GENERAL NOTES

DESIGNER ZDT
REVIEWER RMM 07-22-26
PROJECT ID 116804
SHEET P.3 TOTAL 19

SUM-261-11.89

ITEM 253 - PAVEMENT REPAIR

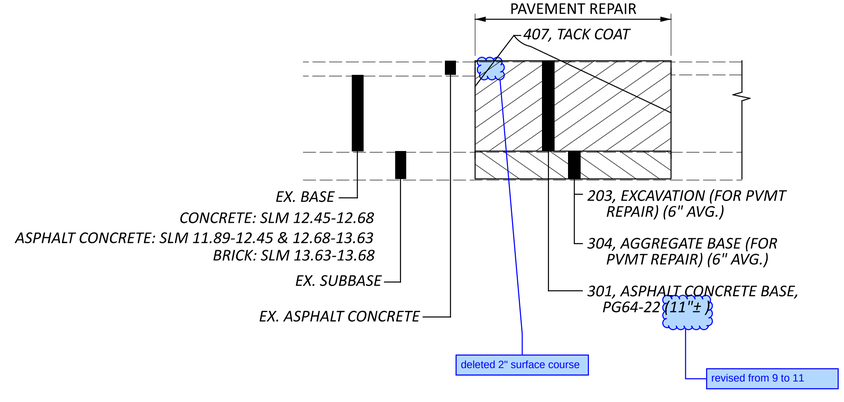
revised from 9 to 11

A QUANTITY OF THIS ITEM SHALL BE PROVIDED FOR USE AS DIRECTED BY THE ENGINEER. THIS ITEM SHALL CONSIST OF CUTTING AND REMOVING DETERIORATED PAVEMENT FULL DEPTH AND PLACING 11" OF 301 ASPHALT CONCRETE BASE, PG64-22. THE MAXIMUM COMPACTED DEPTH OF ANY ONE LAYER SHALL BE 6 INCHES. UNLESS OTHERWISE DIRECTED BY THE ENGINEER, THIS ITEM SHALL BE PERFORMED BEFORE MAINLINE PAVEMENT PLANING AND PRIOR TO THE PLACEMENT OF ASPHALT ON THE MILLED SURFACE.
